Technical Service Bulletin: tsb100593

New Lower Gear Cover

New Gear Cover, Part Number 4973081

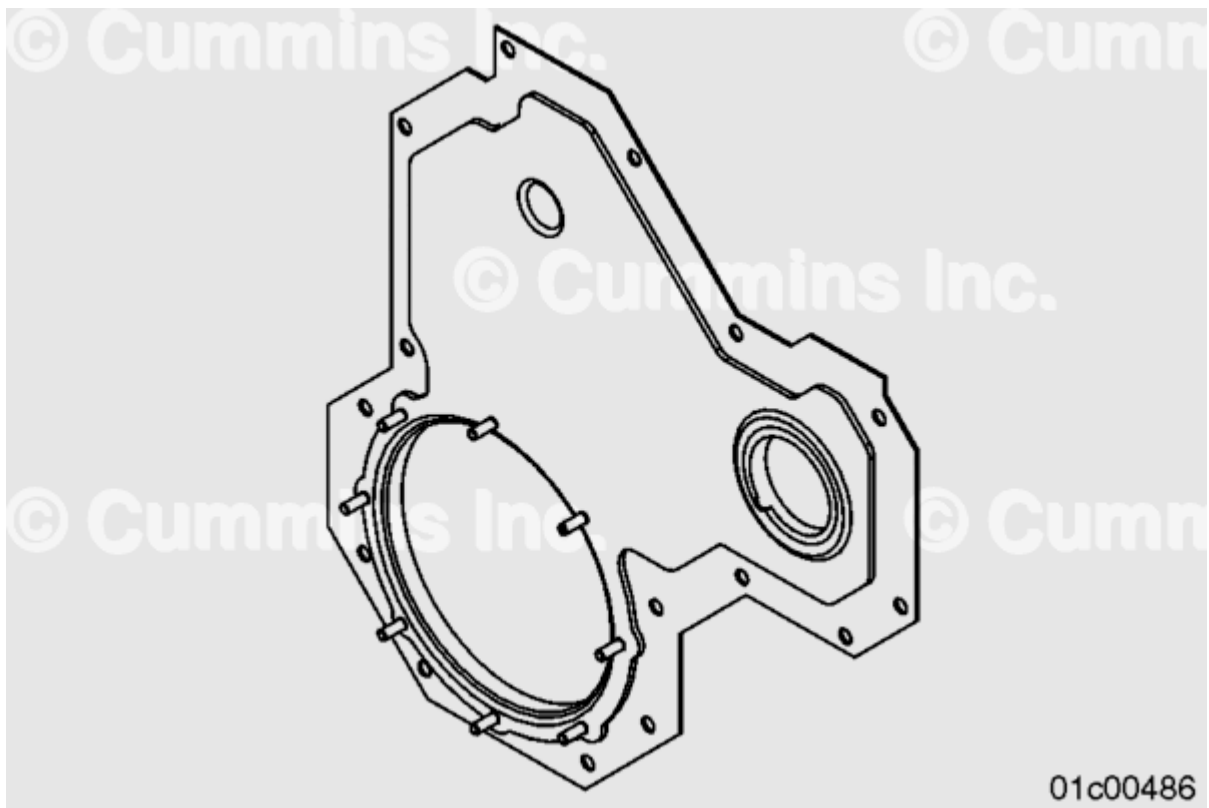
This Technical Service Bulletin introduces a new lower gear cover on all Signature/ISX and QSX15 engines. See the table below for part number status. The new gear cover went into production on 13 March, 2007 with engine serial number (ESN) first 79239101. The new gear cover is backward compatible with all Signature/ISX and QSX15 engines.

The gear cover has been changed in order to eliminate a nominal offset between the crankshaft center line and the center line of the crankshaft seal stud pattern on the gear cover. This offset was found during an investigation into front crankshaft seal oil leaks.
